TSRC PART 2
A.0 - INTERPRETATION

TSRC
PART 2 - CLARIFICATION QUESTION
A.1.1 - Traffic

TSRC
PART 2 - CLARIFICATION QUESTION
A.1.2 - Road Geometry & Road Safety

# Technical State Clarification Questions – NEXUS (03.02.02.19)

# Warrego Highway (East) Grade Separated Intersection

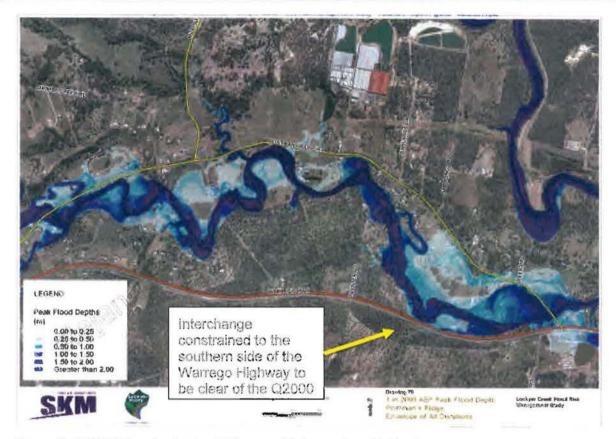
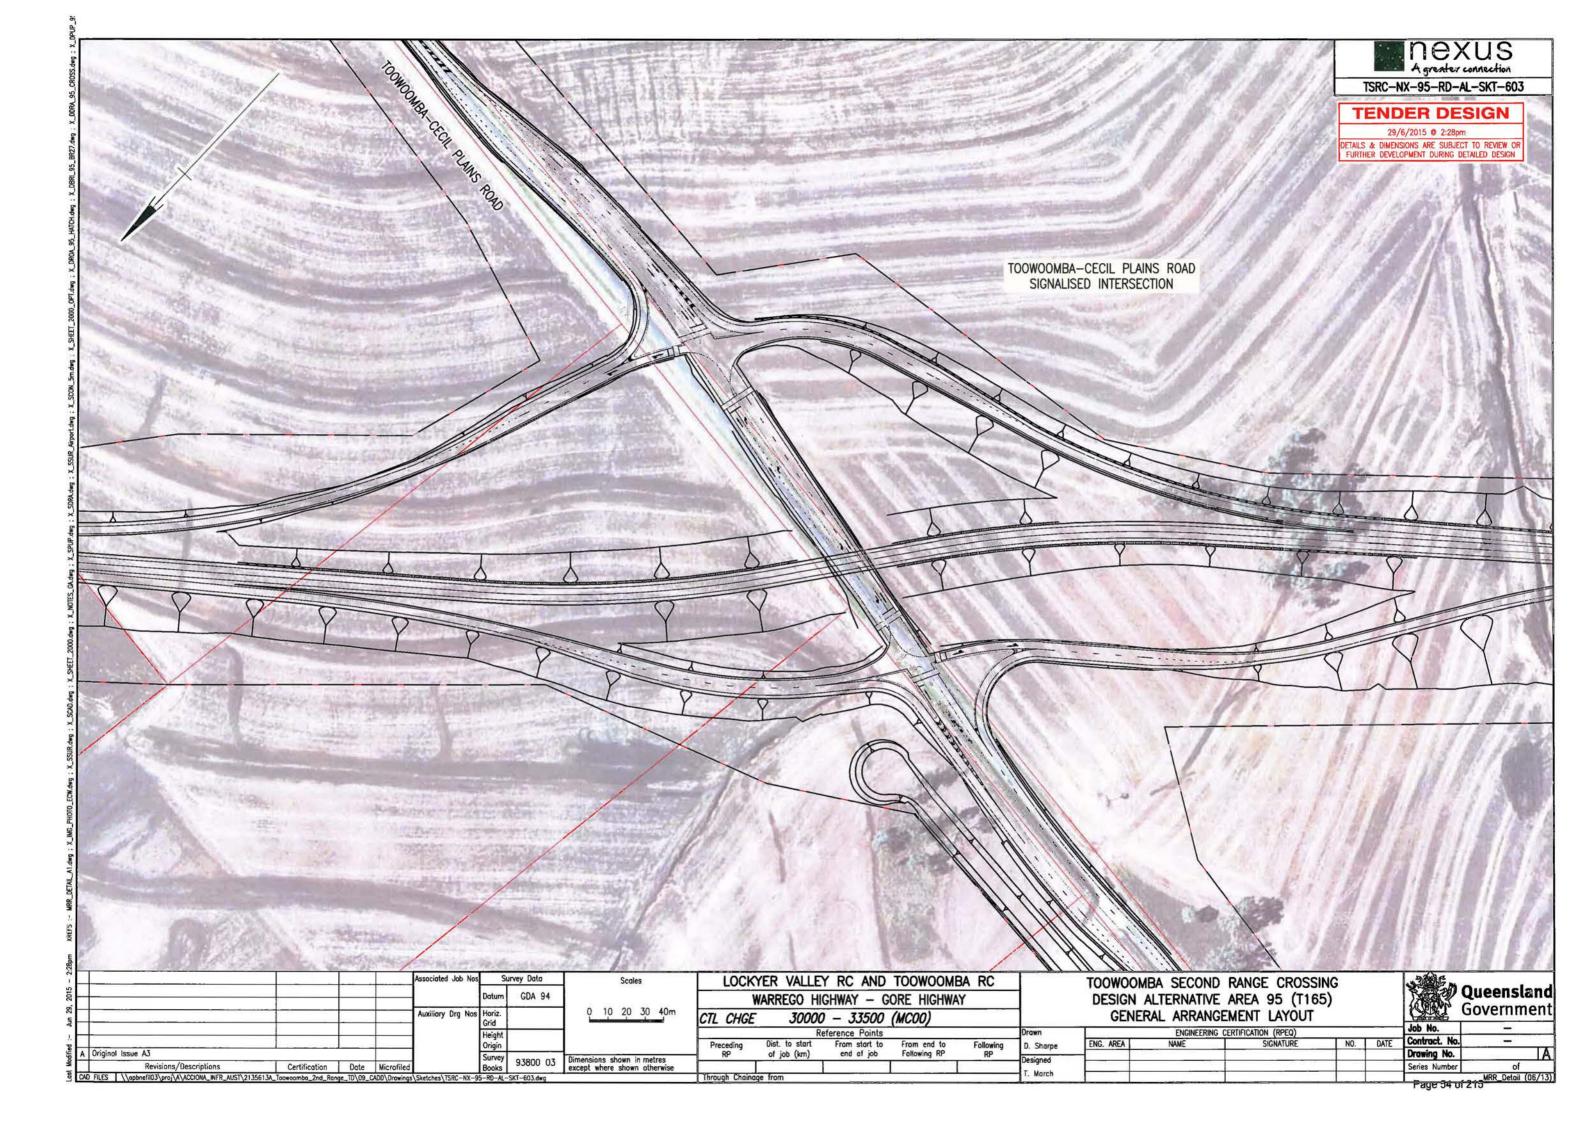
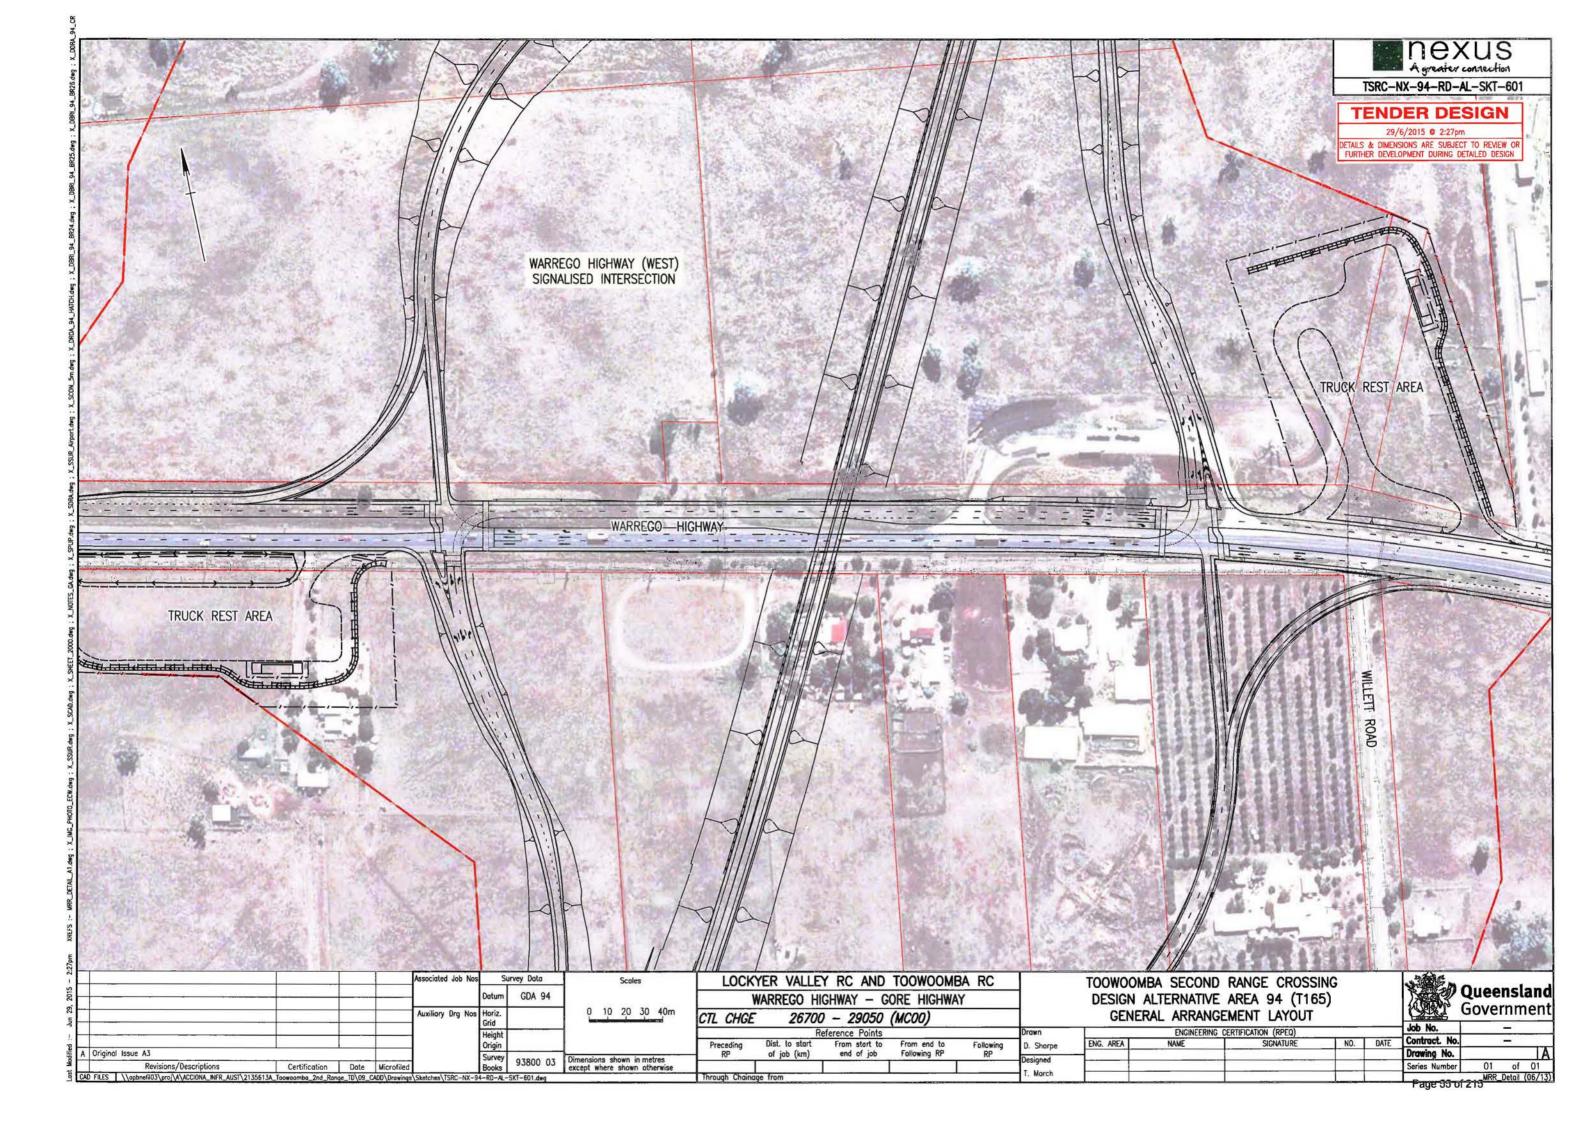
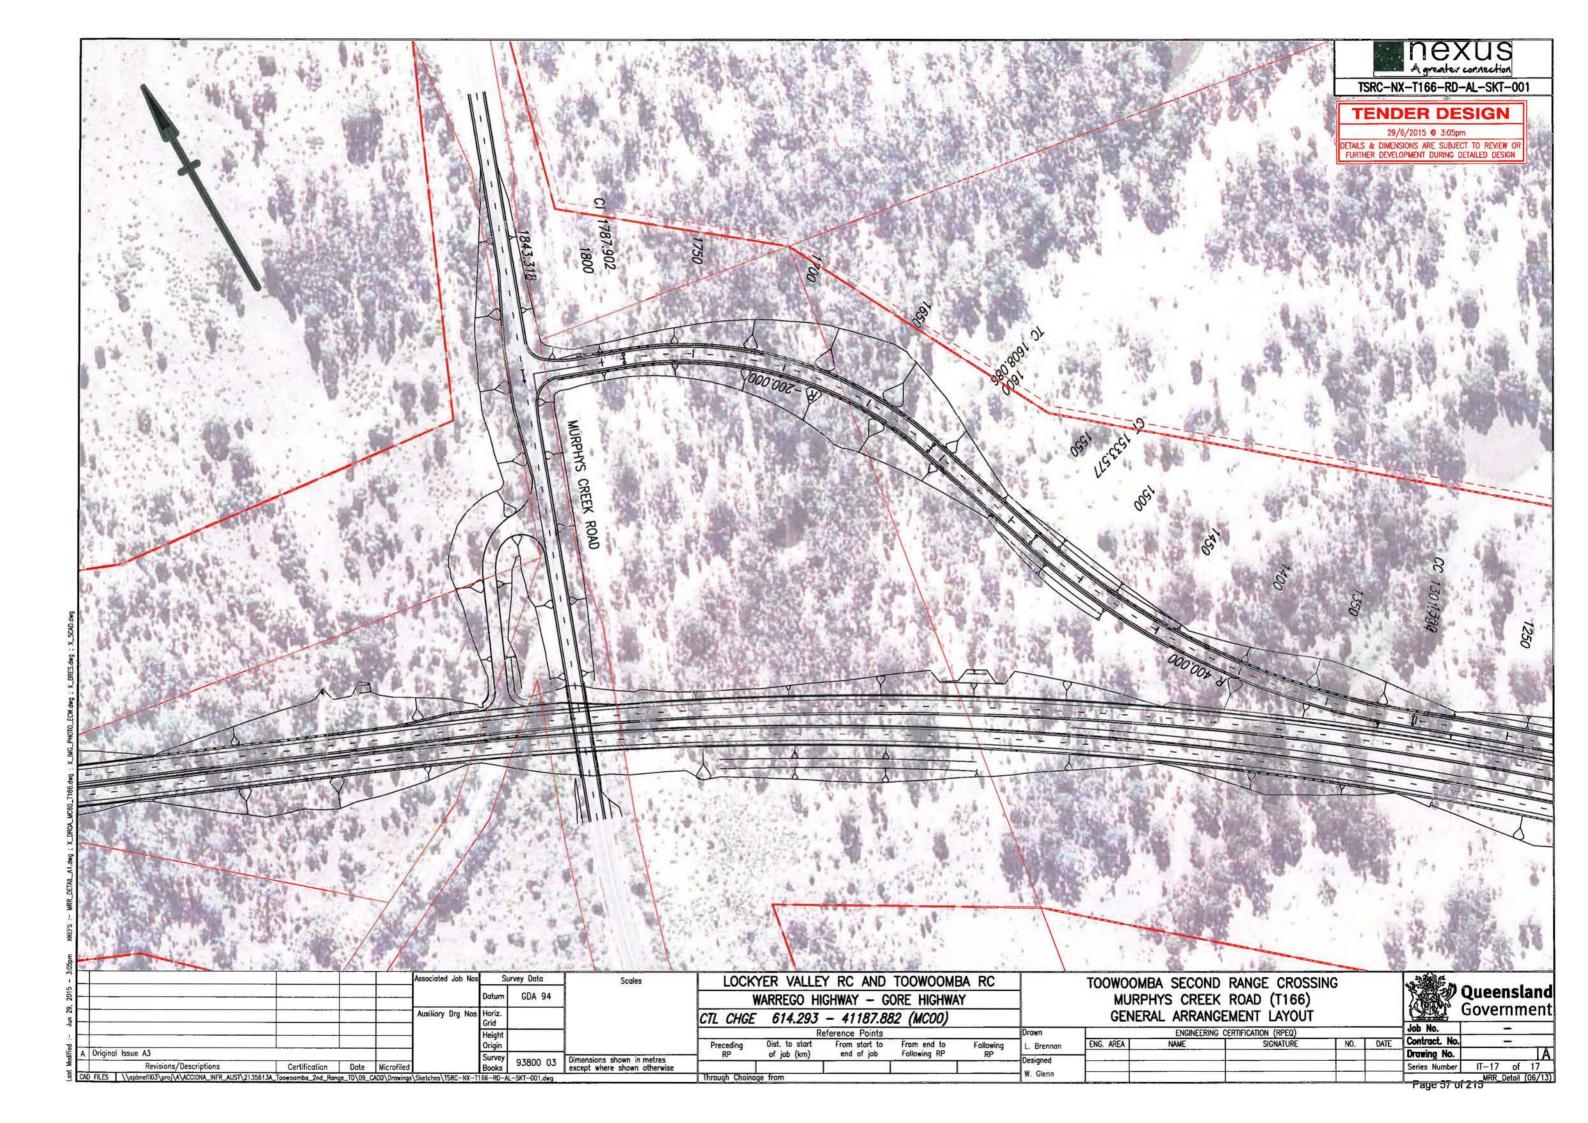
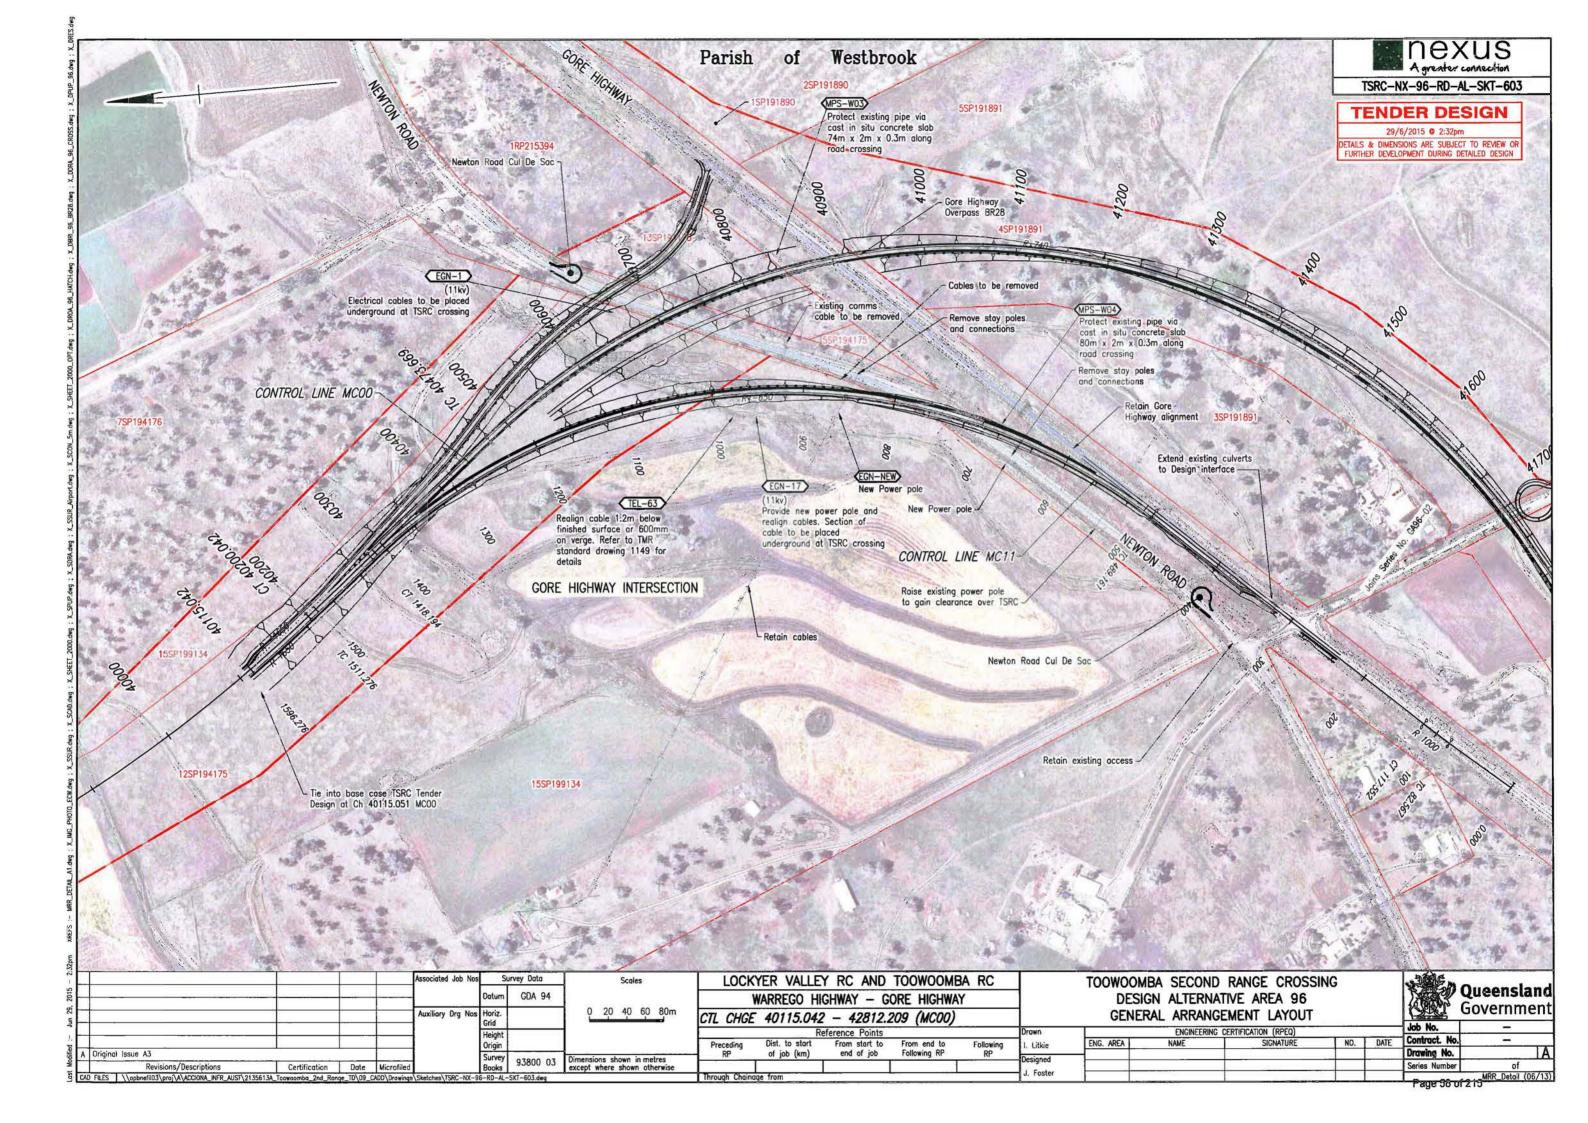
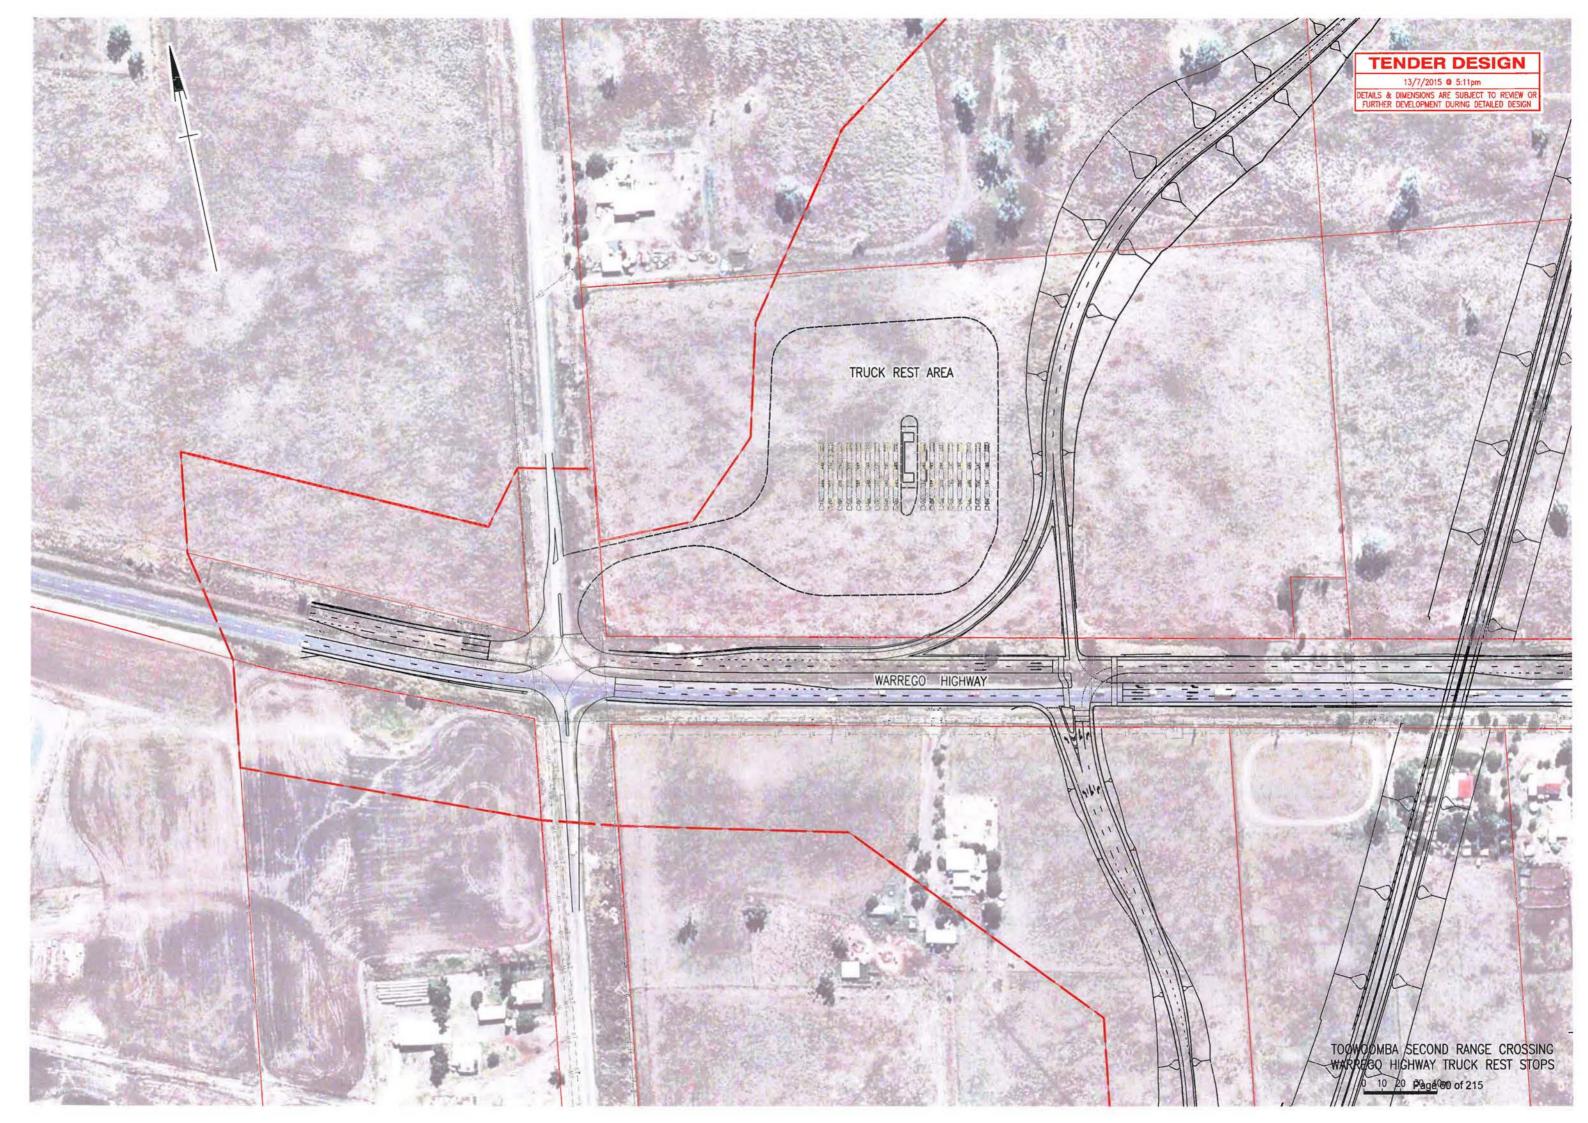
The Technical State Clarification Question T98, issued on 1 April 2015, is the following:

- · comply with the DTMR Road Planning and Design Manual
- comply with Austroads Guide to Road Design Part 4C: Interchanges and as specified below;
- be configured as a two lane exit consistent with Figure 2 a (i) or Figure 4C-6 of the TMR Supplement to Part 4C and consistent with Figure 11.3 of Austroads including an auxiliary lane that is not less than 300m long;

- westbound route from the existing Warrego Highway to the Toowoomba Second Range Crossing being the through route (i.e. vehicles travelling westbound in either existing lane from the Warrego Highway to the Toowoomba Second Range Crossing must be able to effect that manoeuvre without needing to change lanes);

- be configured as a major branch connection generally\* consistent with Figure 11.8: of Austroads with the eastbound route from the Toowoomba Second Range Crossing to the Warrego Highway being the through route (i.e. vehicles travelling eastbound in either iane of the Toowoomba Second Range Crossing to the existing two lane section of the Warrego Highway must be able to effect that manoeuvre without needing to change lanes).

- not provide for any other traffic movements;
- not include any single lane carriageways (i.e. all carriageways must be two lanes west of the
  point where they merge or diverge; and must be two lanes plus auxiliary lanes as appropriate
  [in terms of configuration and length] on the mainline east of that point);

Please advise what impact, if any, this has to your Proposal including program, cost or other related items. Please response by close of business on 20 April 2015.

Nexus has developed an alternative interchange arrangement for the Warrego Highway (east) Interchange which complies with the Performance Specification and the additional requests in the Technical State Clarification Question T94. By complying with the Performance Specification the design also complies with the TMR Road Planning and Design Manual and Austroads Guidelines.

The ITS scheme will not be impacted by the revised interchange layout. From a function perspective over height detection, VMS, and GCTV infrastructure is still required.
